ADDENDUM NO. 1

WASHINGTON STATE PARKS AND RECREATION COMMISSION WILLAPA HILLS STATE PARK TRAIL MENLO TRAILHEAD SW-C1219

DATE: May 29, 2025

TRAIL
RESURFACING

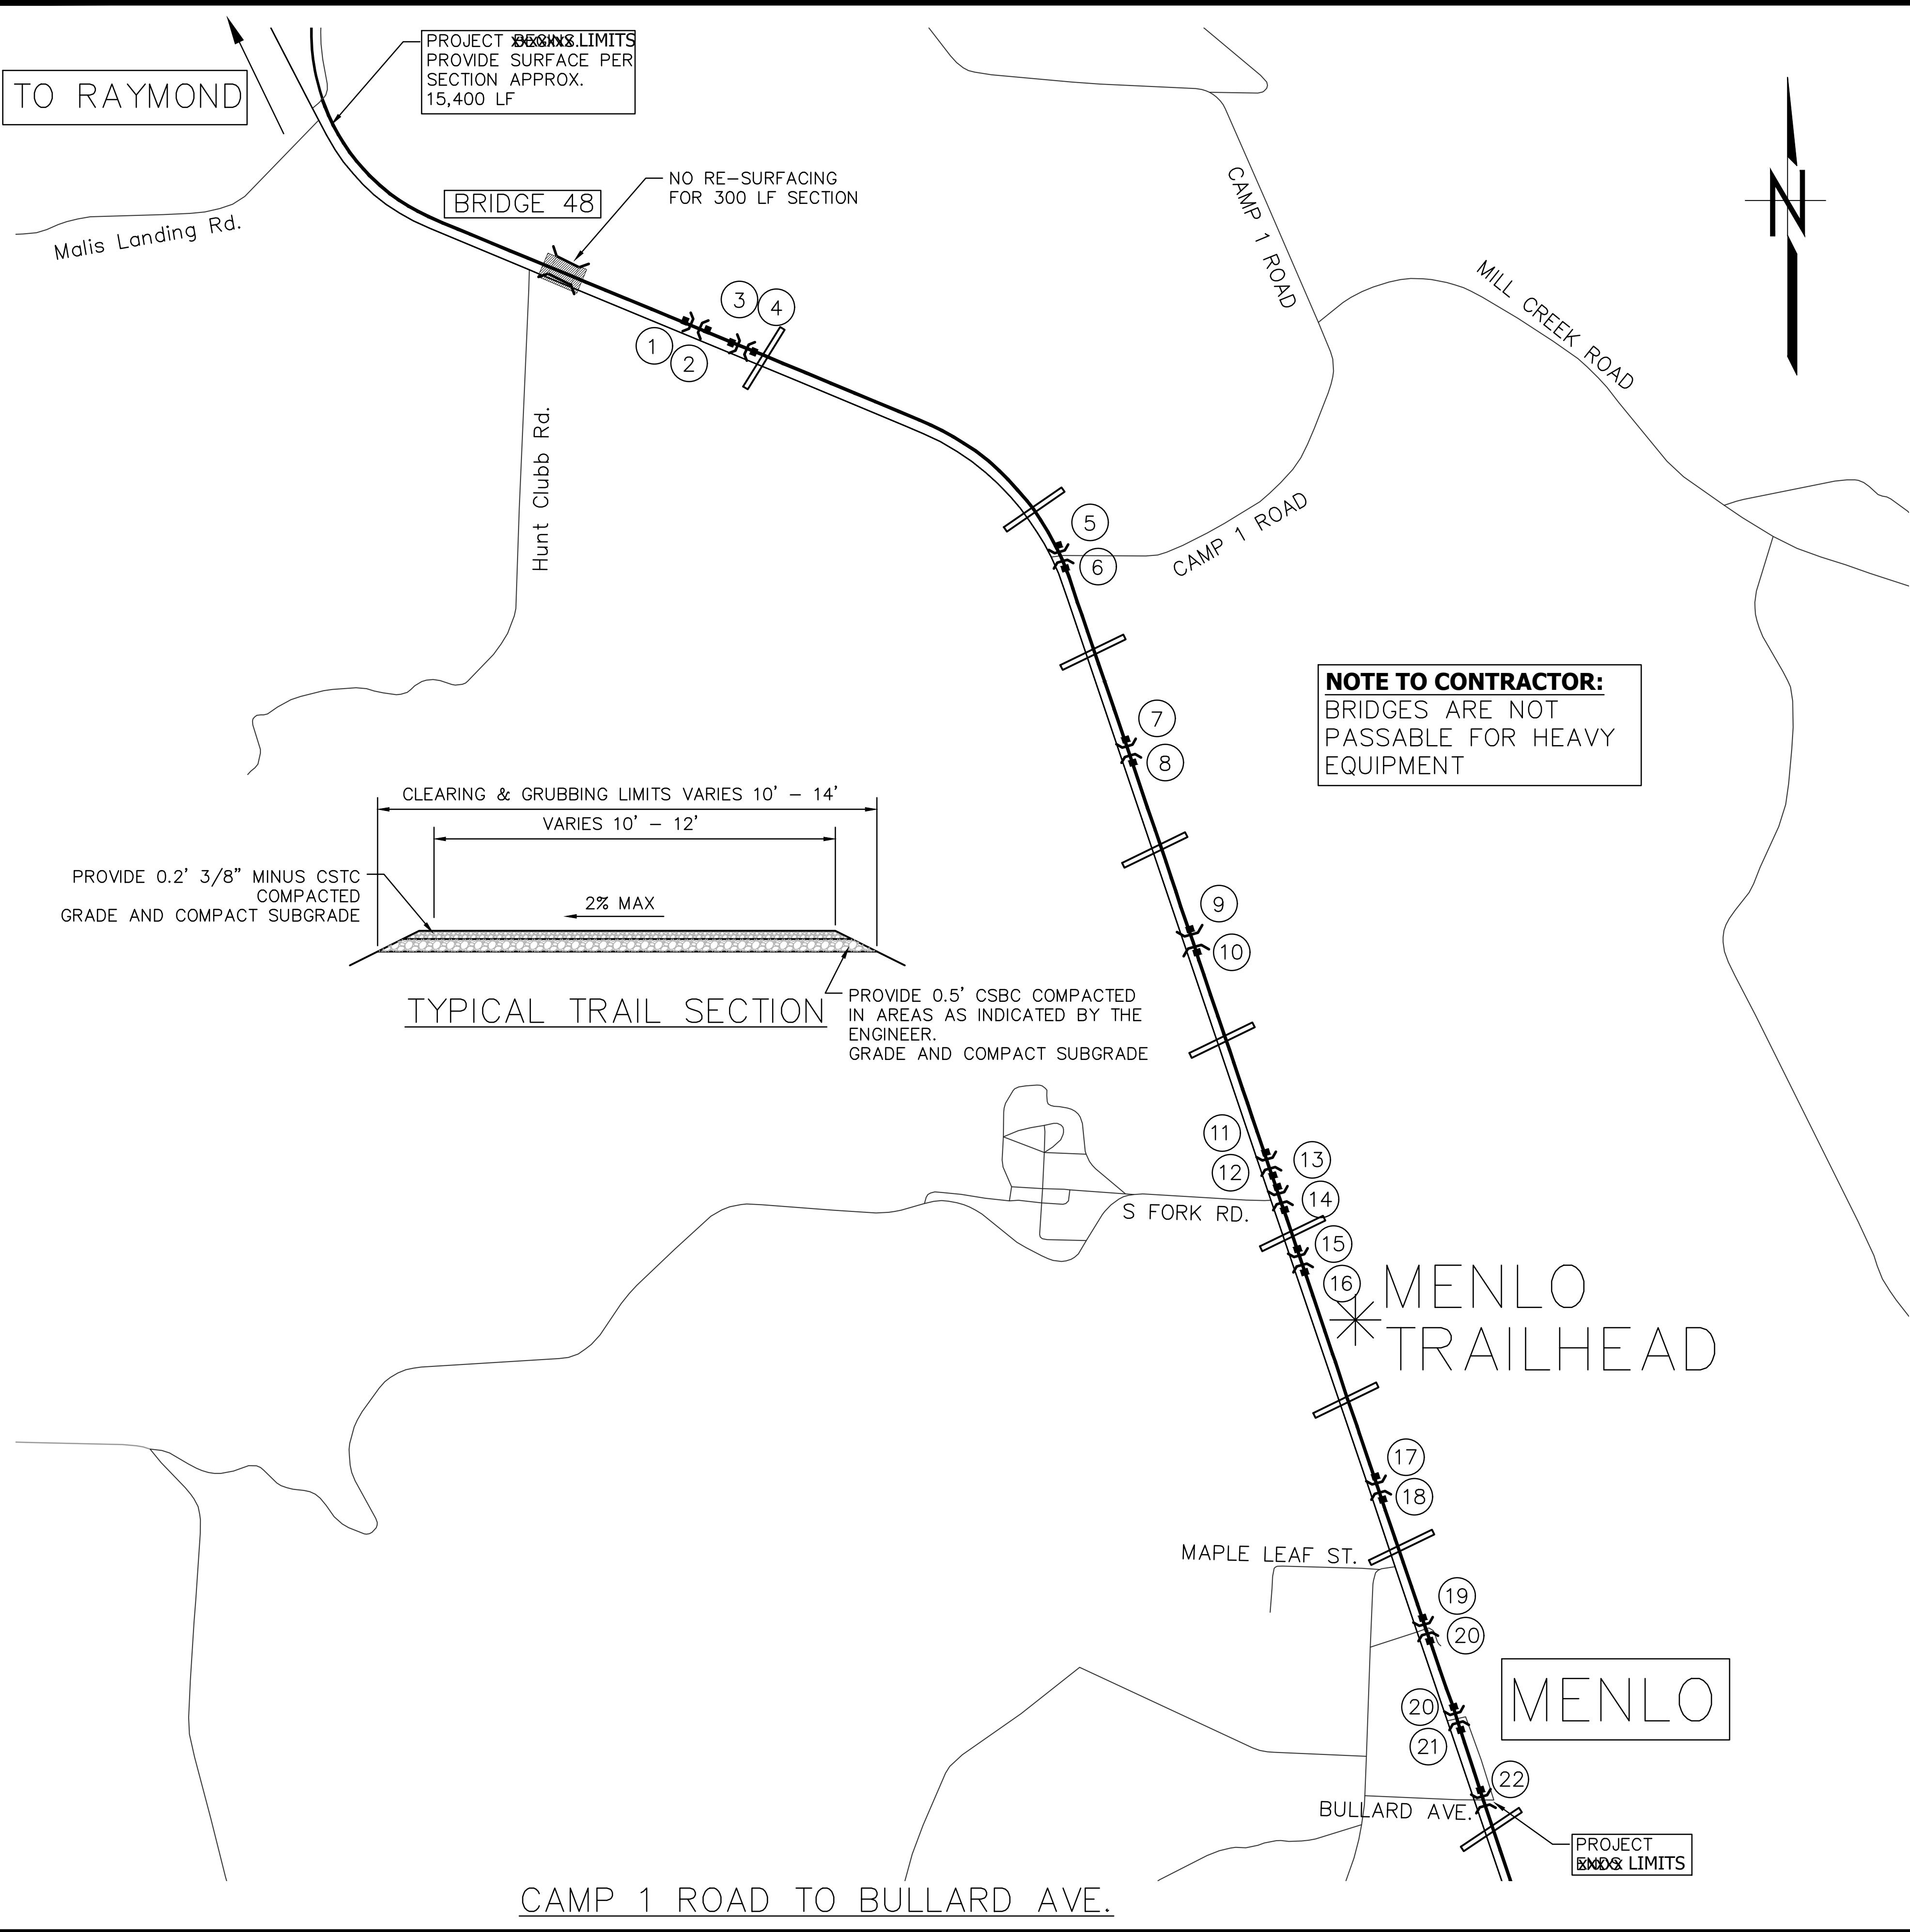
- Sheet 3** **Revise:** Call outs for Kiosk – Install Park Furnished Kiosk See Sheet 10
Call out for Retaining Wall - Provide retaining wall see sheet 4 & 7
- Sheet 7** **Revise:** Retaining Wall Notes – 3. Add or approved equal.
- Sheet 8** **Delete – Not in Contract**
- Sheet 9** **Delete – Not in Contract**
- Sheet 10** **Revise – Only Post Base Detail Included in Contract**
- Sheet 11** **Delete – Not in Contract**
- Sheet 12** **Revise:** Note call out Project Begins Limits & Project Ends Limits
Drawing Legend Notes - Bollard – Install Park Furnished bollards as directed (TYP 44)
22

INSTALL ~~XXXX~~ BOLLARDS AS DIRECTED (TYP ~~XX~~) 22 SEE DETAILS SHEETS 14 & 15
